METROPOLITAN GOVERNMENT OF NASHVILLE AND DAVIDSON COUNTY

STAFF RECOMMENDATION
1303 Edgewood Place
July 16, 2014

Application: New construction—addition and outbuilding; Setback determination.
District: Eastwood Neighborhood Conservation Zoning Overlay
Council District: 06
Map and Parcel Number: 08305025700
Applicant: Preston Quirk, architect
Project Lead: Melissa Baldock, melissa.baldock@nashville.gov

Figure 2. The addition will extend to the width of this bay.

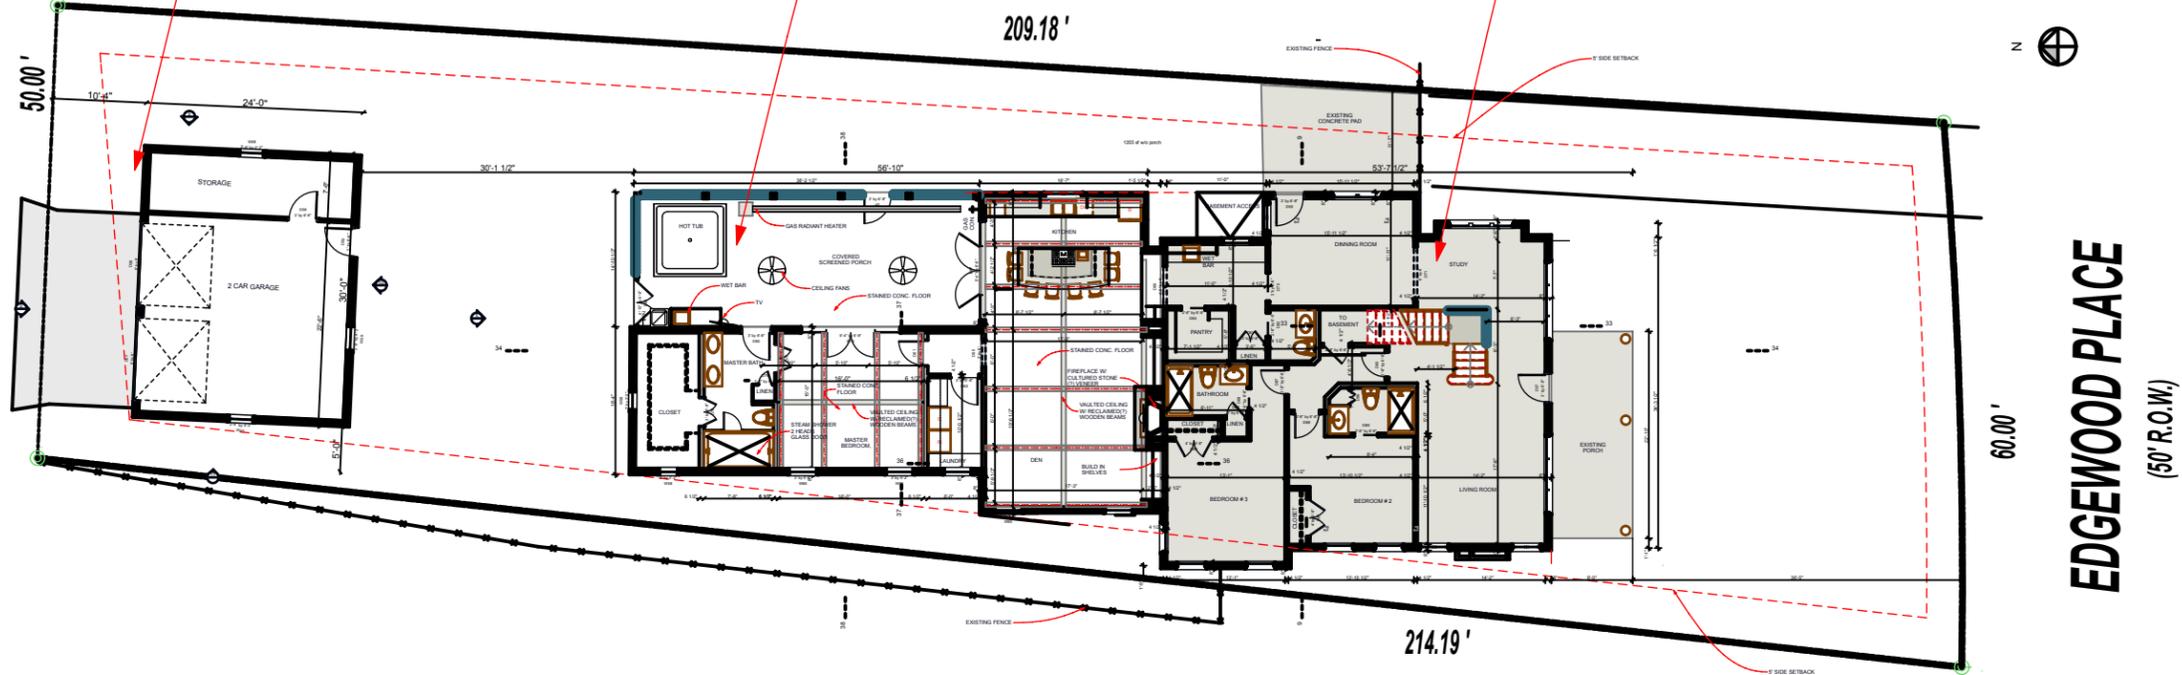
The addition is appropriately inset from the historic house on both sides, and is no wider than the historic house. On the right side, the addition is inset approximately eighteen inches (18") for a depth of approximately eighteen inches (18"). After that point, the addition extends out five feet

(5') to line up with the width of the historic house's protruding bay (Figure 2). On the left side, the addition is inset approximately six feet (6') at the back of the historic house, and then steps in another four feet, six inches (4'6") further back in order to meet the five foot (5') side setback. The addition is approximately fifty-six feet, ten inches (56'10") deep. The total footprint for the addition is approximately one thousand, eight hundred and seventy-six square feet (1,876 sq. ft.), which is slightly larger than the footprint of the historic house, which is approximately one thousand, eight hundred and twenty-six square feet (1,826 sq. ft.). Staff finds the slightly larger footprint to be appropriate in this instance because the addition is over five feet (5') shorter than this historic house, it is no wider than the historic house, and it steps in appropriately. Overall, the addition is subordinate to the historic house, and staff therefore find that the addition meets Sections II.B.1.a., II.B.b., and II.B.2. of the design guidelines.

SITE PLAN

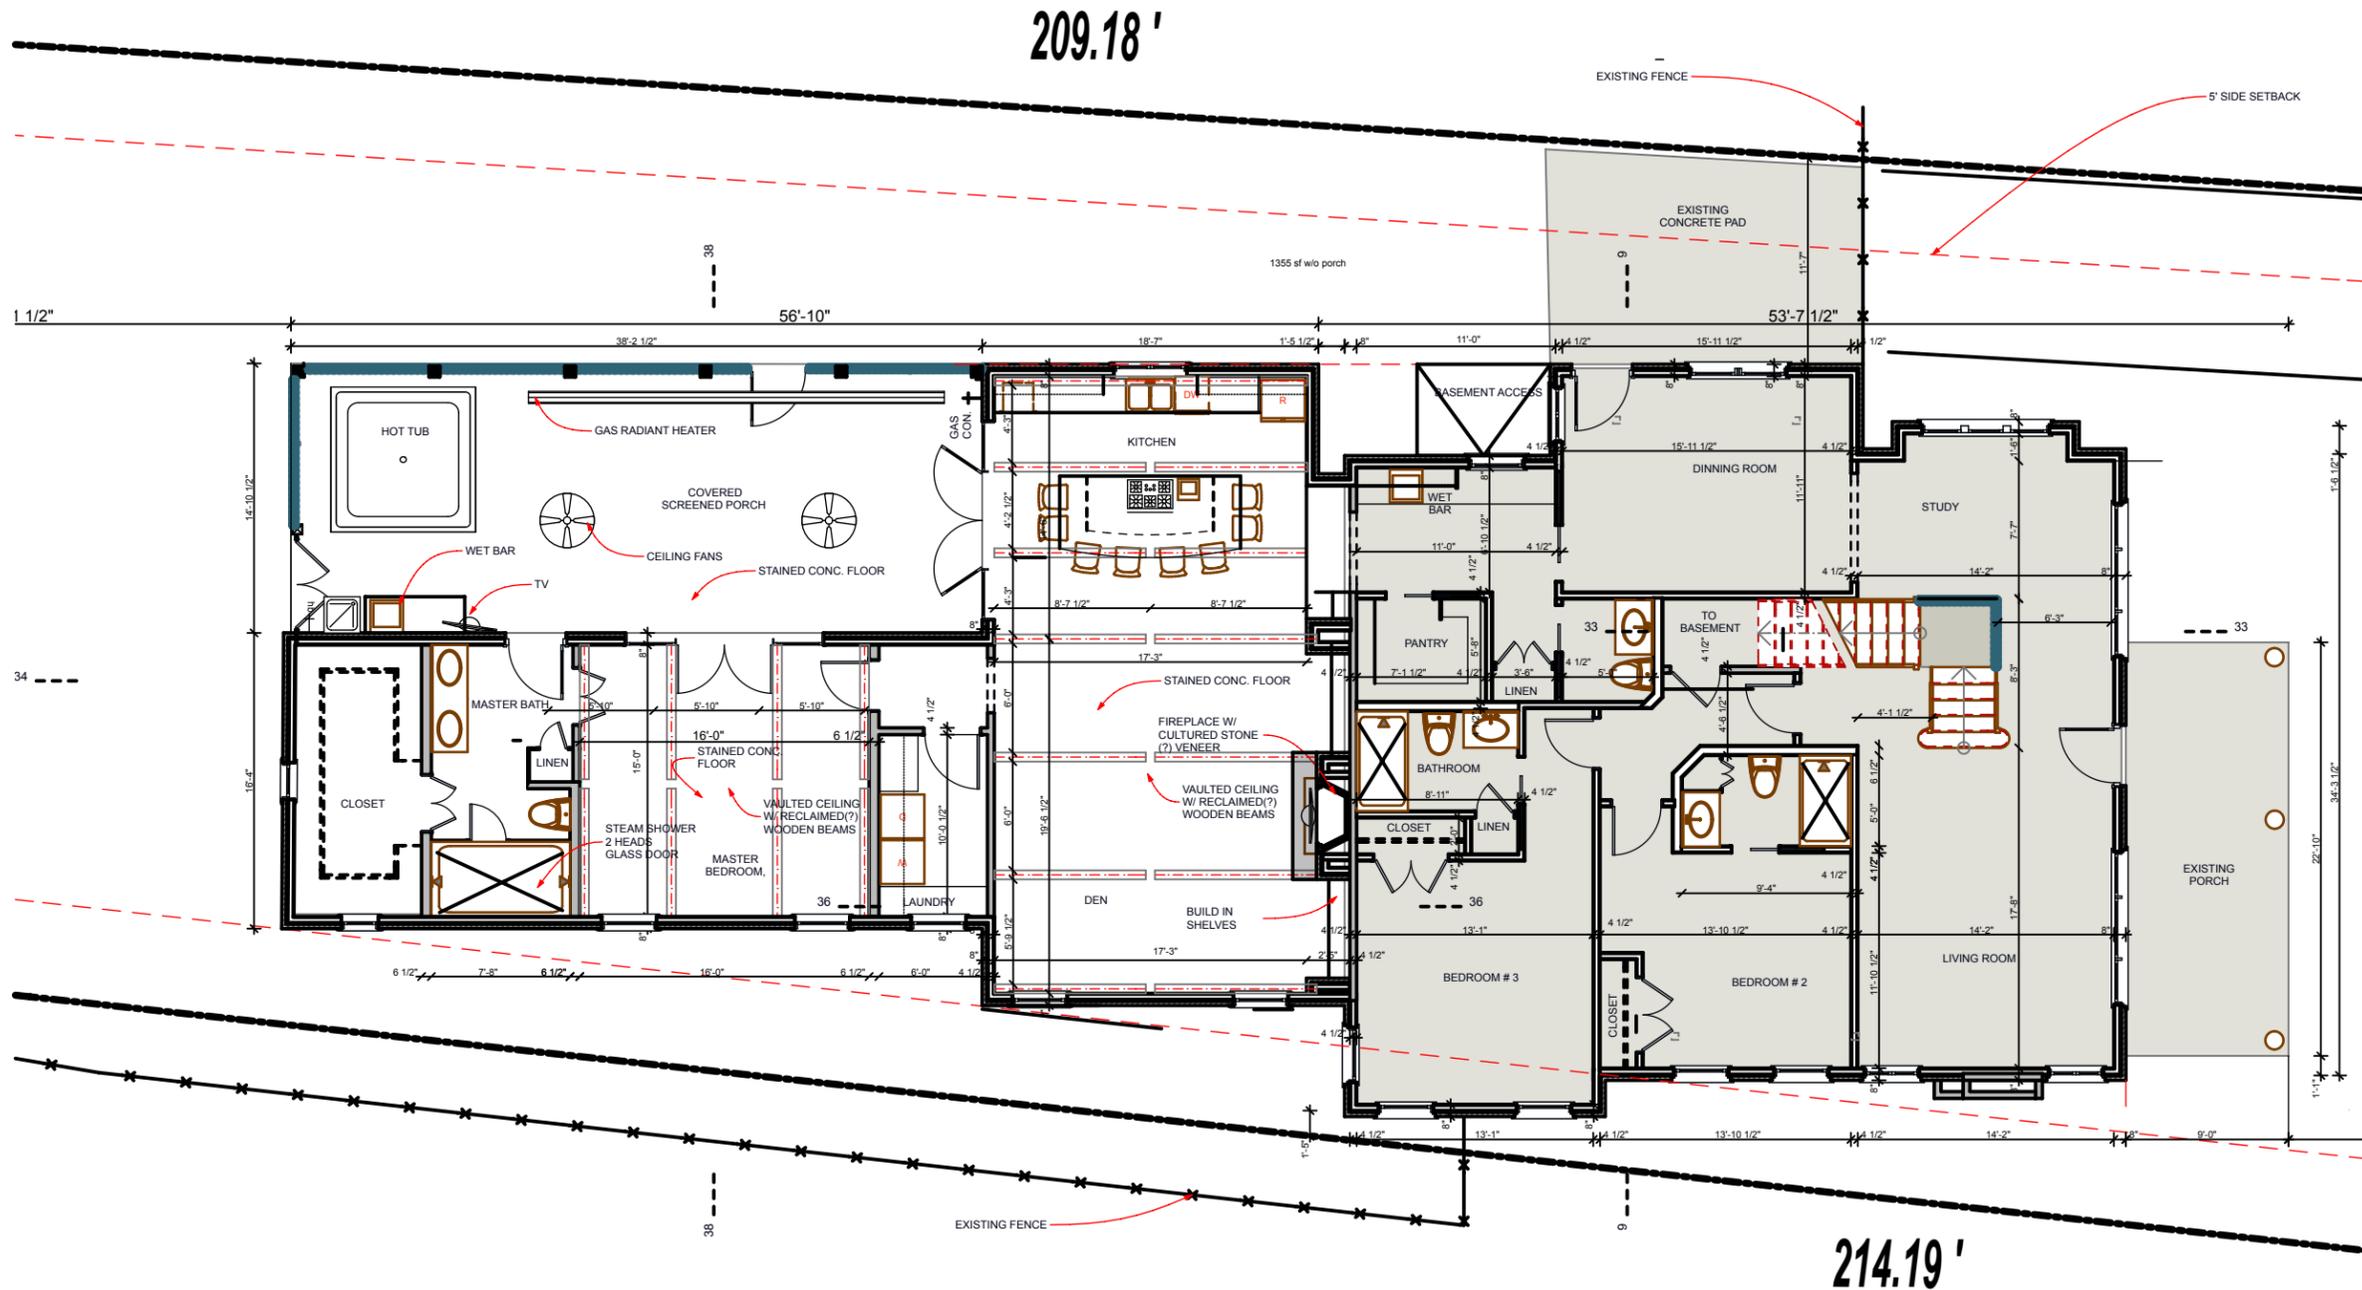
The applicant proposes to construct a rear addition and an outbuilding. The outbuilding requires a setback determination for the rear setback. Because the outbuilding's footprint is over seven hundred square feet (700 sq. ft.) and because the rear property line faces

Seymour Avenue, not an alley or a shared property line, base zoning requires that the outbuilding be placed twenty feet (20') from the rear property line. The applicant is proposing to place the outbuilding just ten feet (10') from the rear property line.

The outbuilding will be located over five feet (5') from the two side property lines, thereby meeting the base zoning setbacks. The outbuilding requires a setback determination for the rear setback. Because the outbuilding's footprint is over seven hundred square feet (700 sq. ft.) and because the rear property line faces Seymour Avenue, not an alley or a shared property line, base zoning requires that the outbuilding be placed twenty feet (20') from the rear property line. The applicant is proposing to place the outbuilding just ten feet (10') from the rear property line. Staff finds this to be appropriate because historically, outbuildings were located on or near the rear property lines. In addition, there are other outbuildings along the north side of Seymour Avenue that are situated less than twenty feet (20') from the rear property line (see Figure 3).

F, R ELEVATIONS

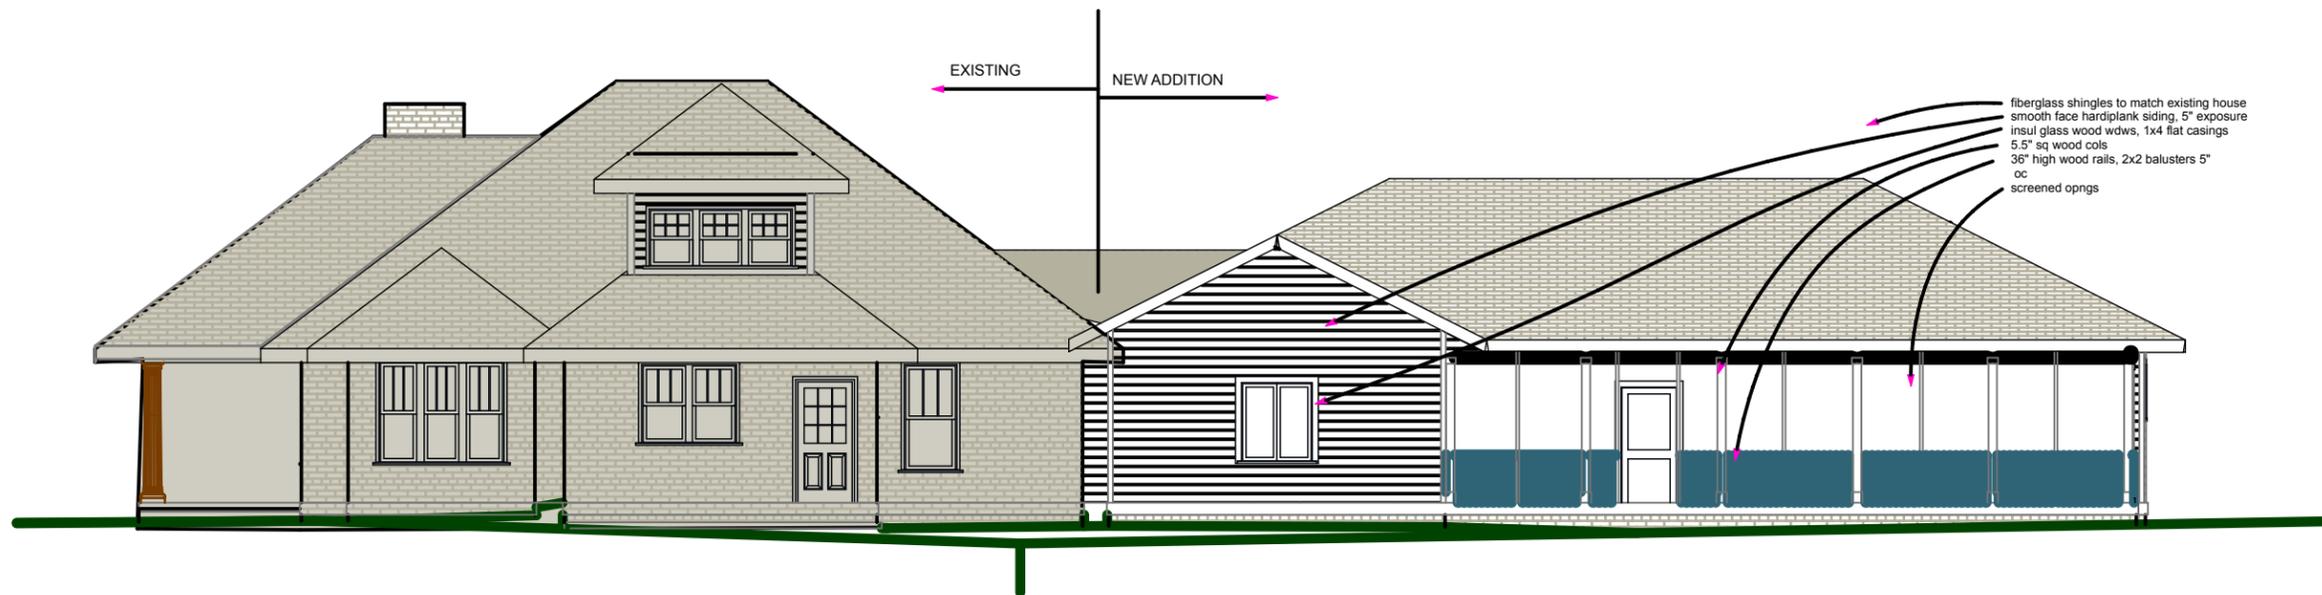
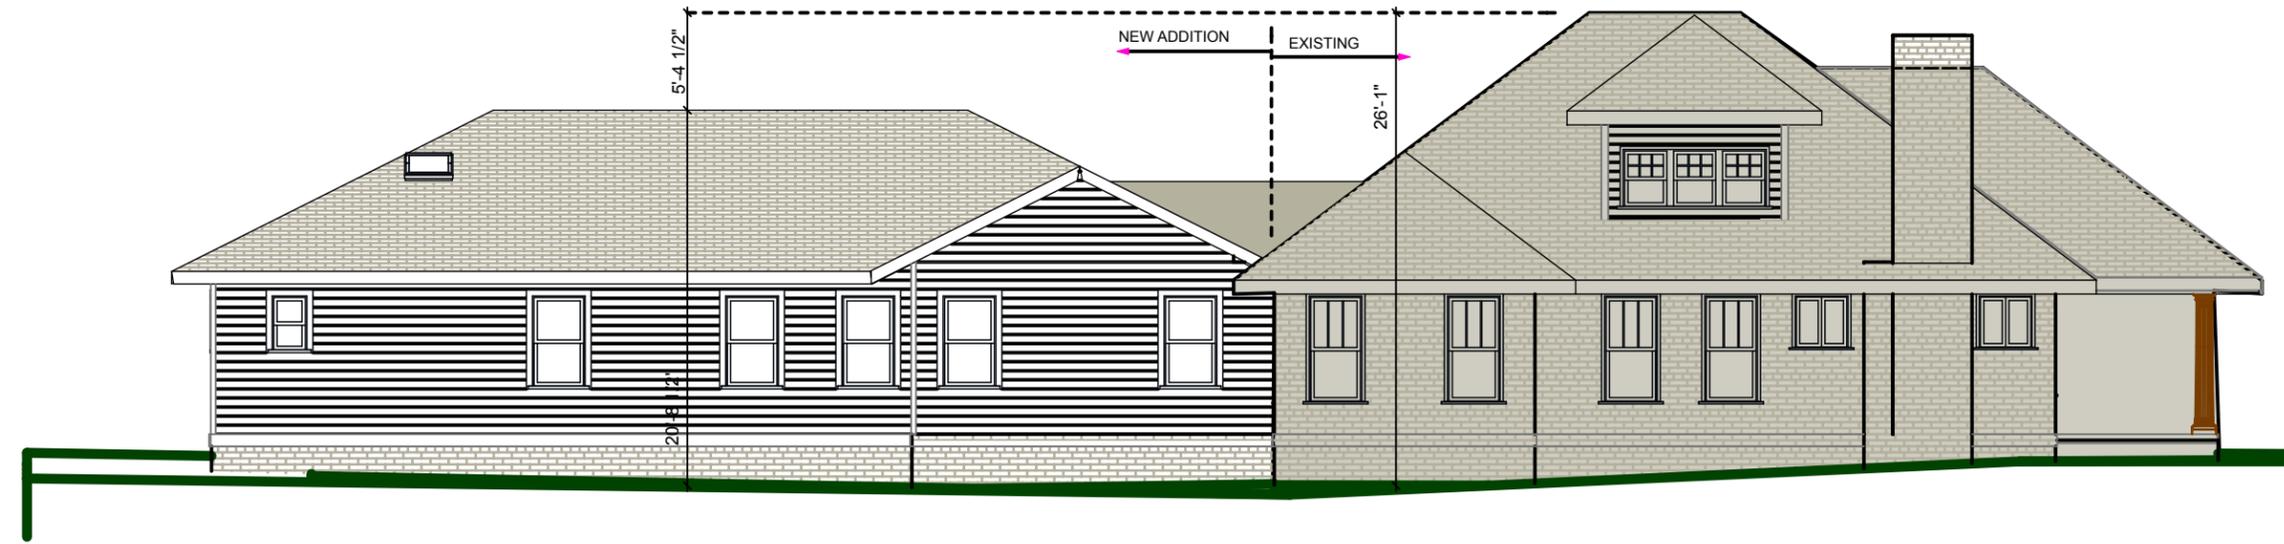
Height & Scale: The rear addition has an eave height that matches that of the historic house, but its ridge height is lower than that of the historic house. The historic house has a ridge height of approximately twenty-five feet (25'). The addition ties into the back of the house at a height of approximately sixteen feet (16'), and has a maximum ridge height of nineteen feet (19'). Staff finds that the addition's height meets the design guidelines.

Roof form: The historic house has a hipped roof form with a slope of 9/12. The proposed addition ties into the historic house with a 3/12 hipped connector, and addition's primary roof form will be hipped with a slope of 6/12. Staff finds that the proposed roof form is compatible with the historic house's roof form and meets Section II.B.1.e. and II.B.2. of the design guidelines.

Proportion and Rhythm of Openings: No changes to the window and door openings on the existing house were indicated on the plans. The windows on the proposed addition are all generally twice as tall as they are wide, thereby meeting the historic proportions of openings. There are no large expanses of wall space without a window or door opening. Staff finds the project's proportion and rhythm of openings to meet Section II.B.1.g. and II.B.2. of the design guidelines.

1. Staff approve the foundation material and all window and door specifications prior to purchase and installation; and
2. The HVAC unit be placed on the rear façade, or on a side façade beyond the midpoint of the house.

1 GARAGE PLAN
SCALE: 1" = 10'

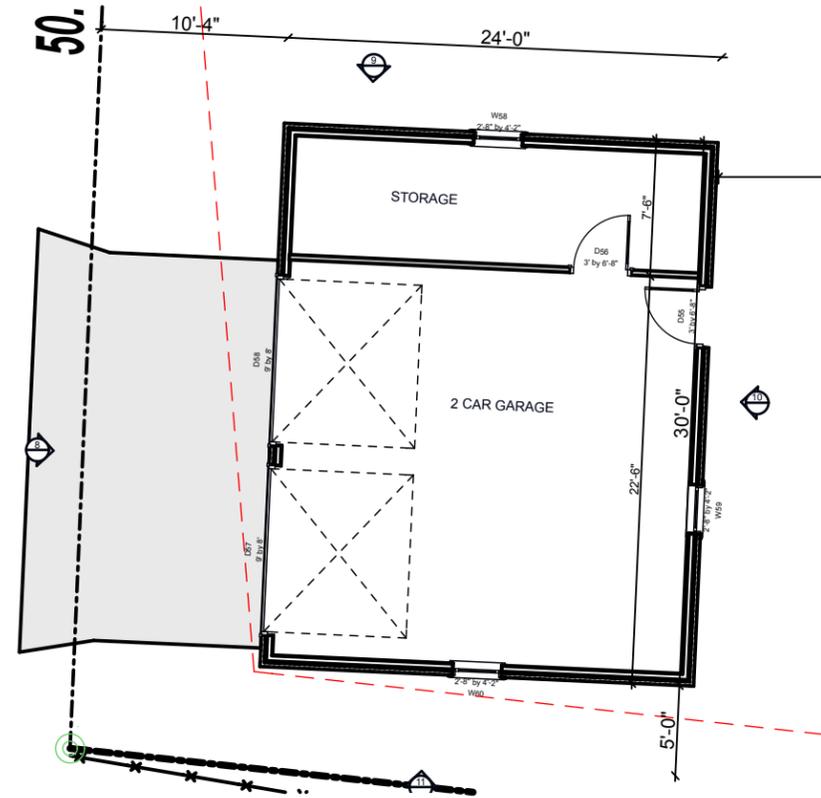
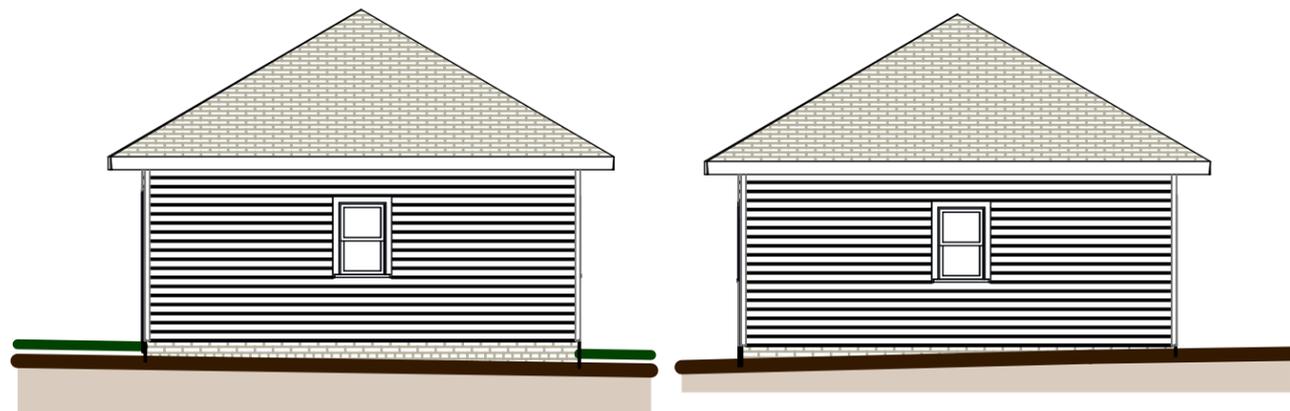
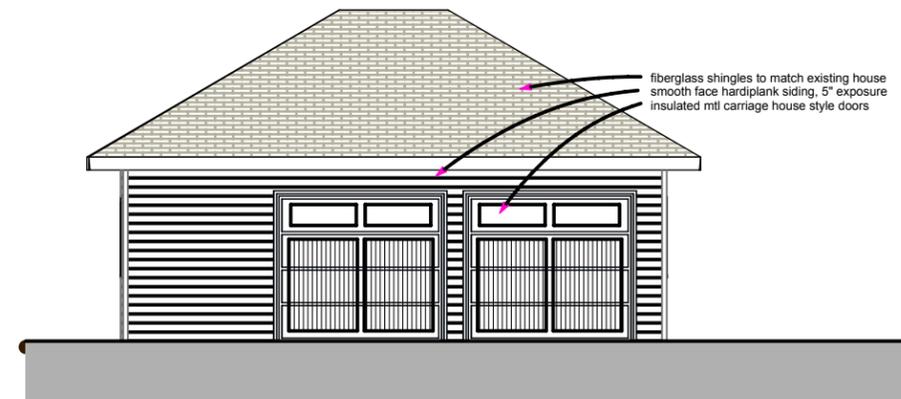
Outbuildings: The applicant is proposing to construct a one-story garage that is twenty-four feet (24') deep and thirty feet (30') wide, or seven hundred and twenty square feet (720 sq. ft.). The outbuilding's eave height will be nine feet (9'), and its ridge height will be eighteen feet (18'), both of which are subordinate to the historic house. The garage will be located in the rear of the property, and will be accessed via Seymour Avenue, which is at the rear property line. Because many of the historic houses on the north side of Edgewood Place are situated on lots that extend through to Seymour Avenue, and because there are no historic houses facing this block of Seymour Avenue, staff finds that the location and orientation of the garage are appropriate (Figure 3).

The garage will have a hipped roof form with a slope of approximately 6/12. Its materials will be similar to those proposed for the addition, and include smooth-face cement fiberboard with a five inch (5") reveal, metal garage doors, wood windows, and fiberglass shingles to match the color of the house's shingles. The garage's proportion and rhythm of openings are appropriate for an outbuilding. Staff finds that the proposed outbuilding meets Section II.B.1.h. of the design guidelines.
